# CITY OF ALBUQUERQUE

**RE: 907 Laurel Cir SE  
Grading & Drainage Plan  
Engineer's Stamp Date: 2/11/26  
Hydrology File: L17D031  
Case # HYDR-2026-00055**

Based upon the information provided in your submittal received 2/12/2026, the Grading & Drainage Plan **is not approved** for Grading Permit or Building Permit. The following comments need to be addressed for approval of the above referenced project.

ENGINEER'S SEAL	LOT 15-A, BLOCK 34 PARKLAND HILLS ADDITION 907 LAUREL CIR SE GRADING AND DRAINAGE PLAN	DRAWN BY MM
		DATE 2-12-2026
	2/11/26	 Rio Grande Engineering P.O. BOX 93894 ALBUQUERQUE, NM 87199 (505) 321-8099
DAVID SOULE P.E. #14522	JOB #

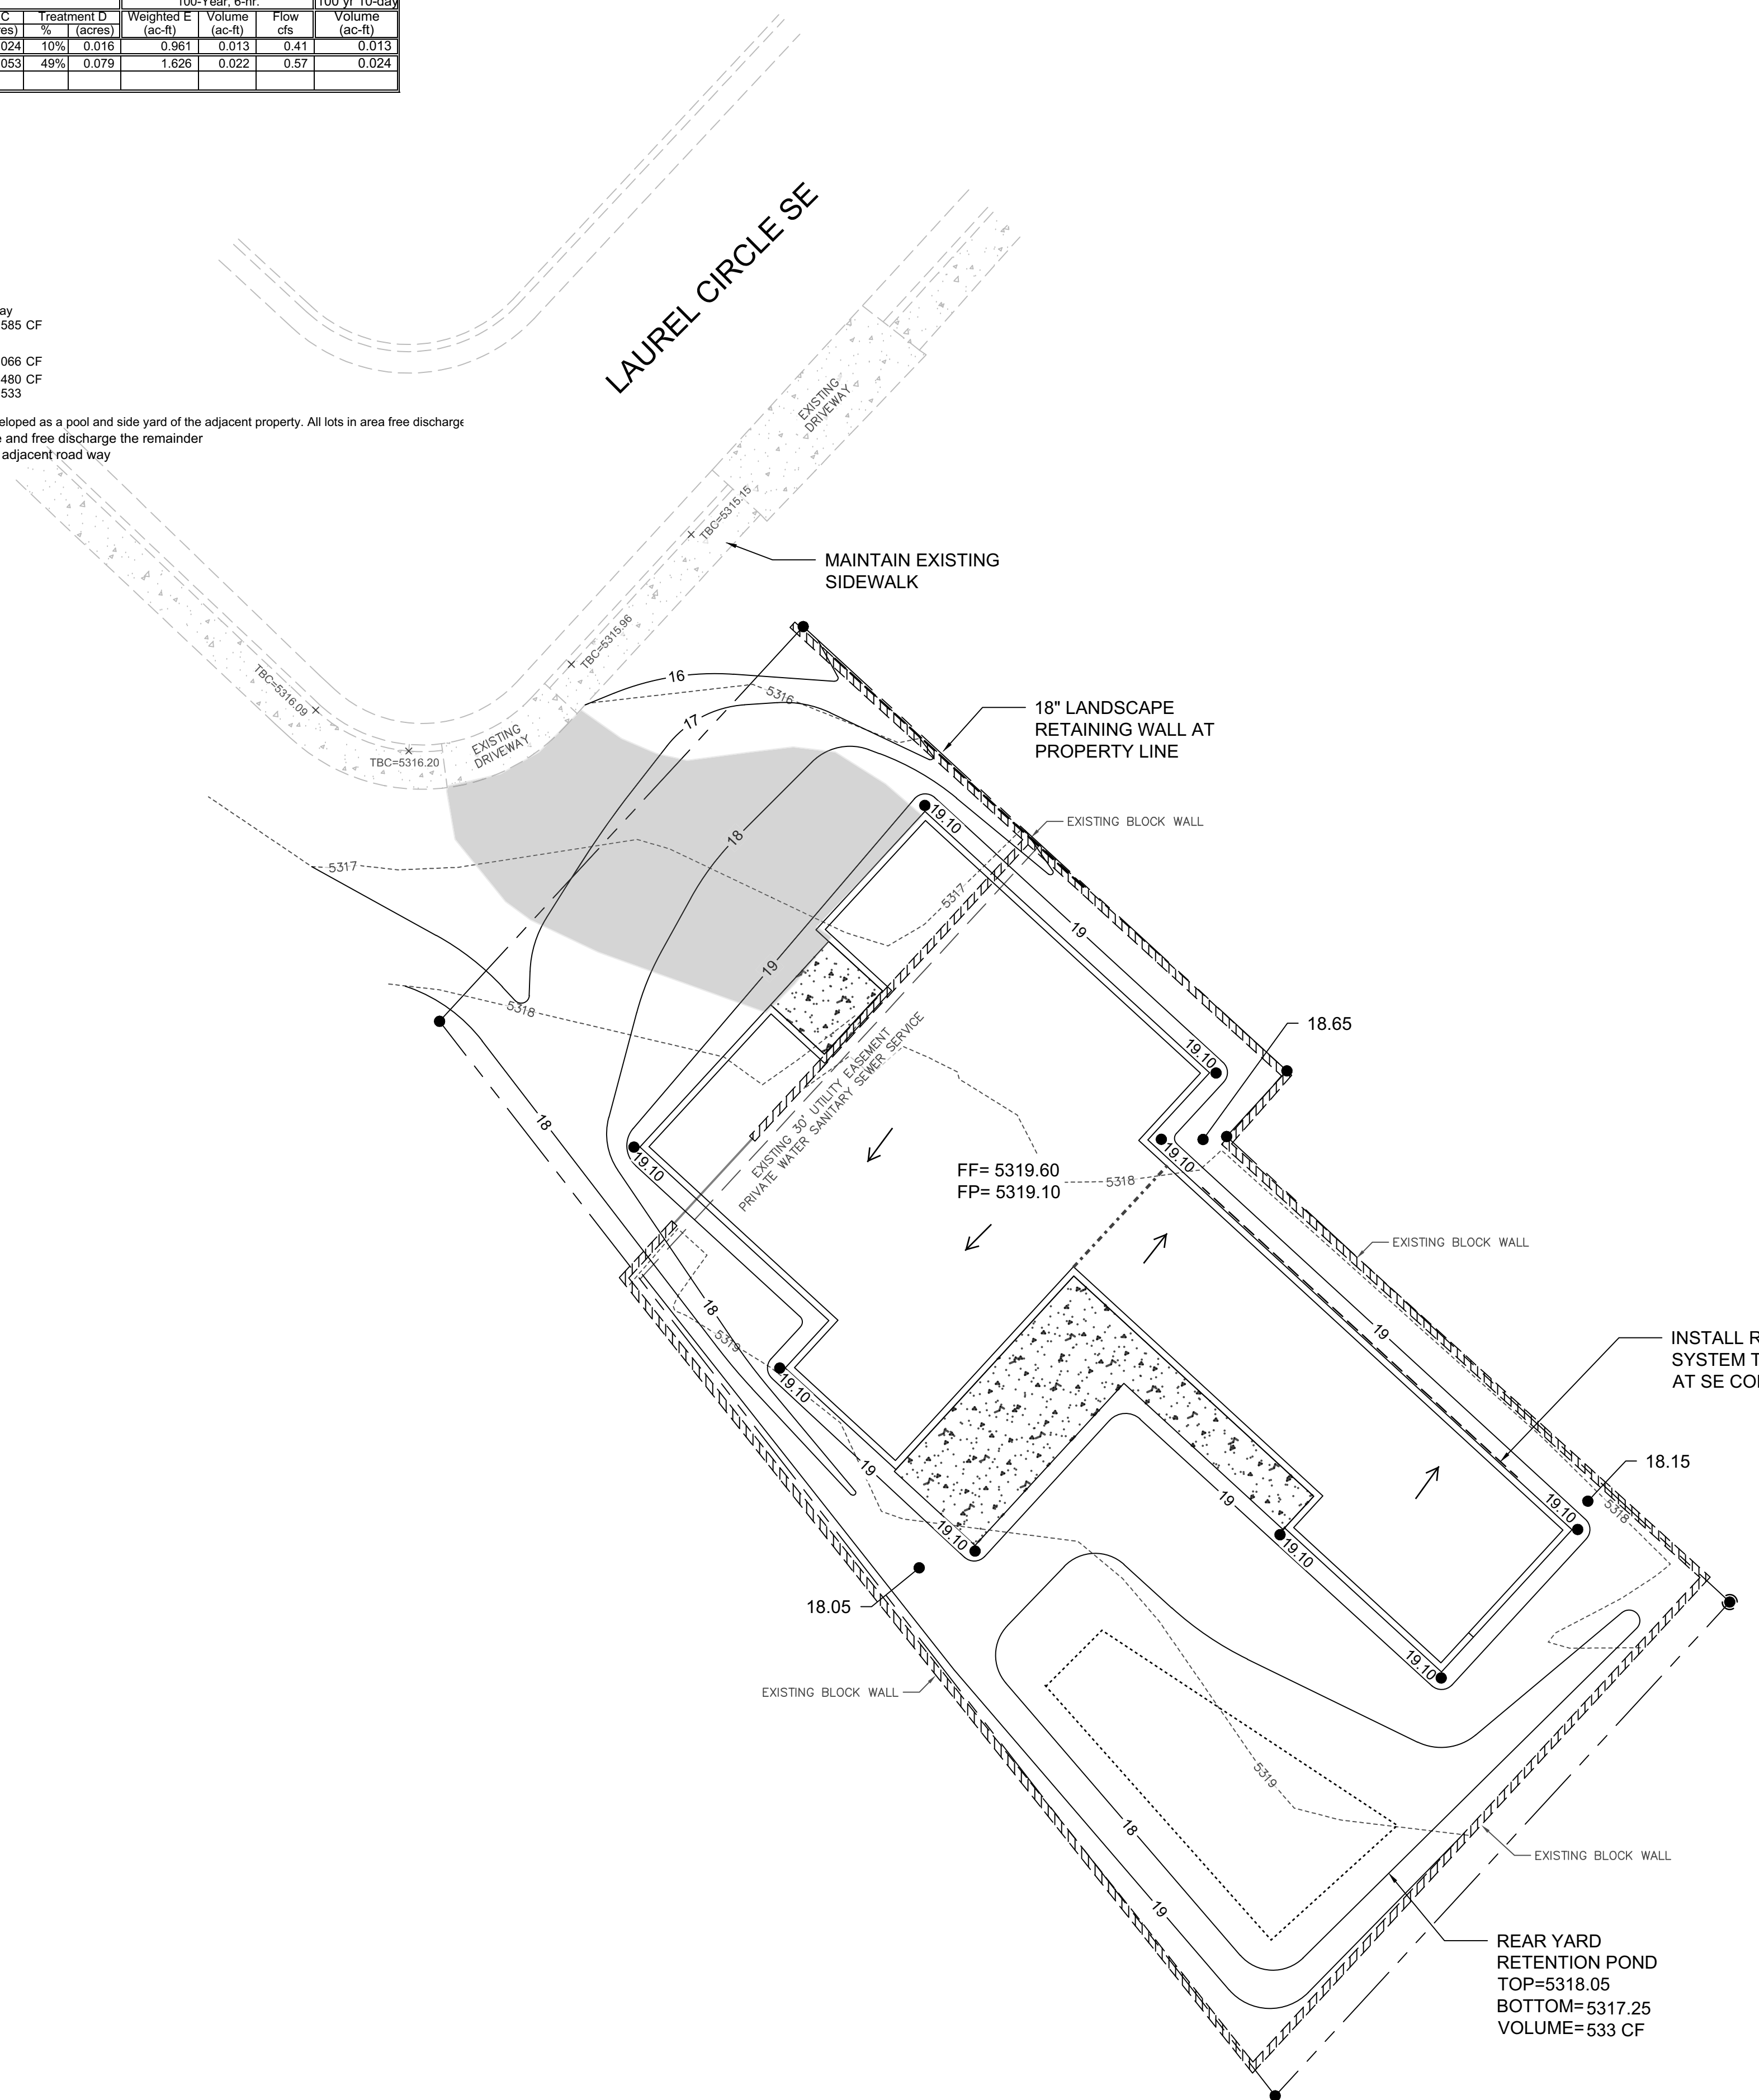
1. Remove Note 5. A pad elevation certification is not required for this project.
2. Provide the existing and proposed grades on both sides of the proposed 18" landscape retaining wall.

3. Provide sections through all external boundaries showing proposed retaining walls, garden walls, property/ROW lines, existing and proposed grades. In accordance with DPM Ch.22, section 5 part B, grading and wall construction near the property line may not endanger adjacent property or constrain its use.

4. If the proposed retaining wall will create such an encroachment, written agreement from both landowners must be provided for such work. Written permission must include: signature of the property owner or owner's representative, statement that undersigned is the owner or authorized representative, permission to construct the encroachment with a brief description of the encroachment.

5. Any private encroachment into neighboring private property will require written and signed (and notarized) permission from both property owners. See #4 above.
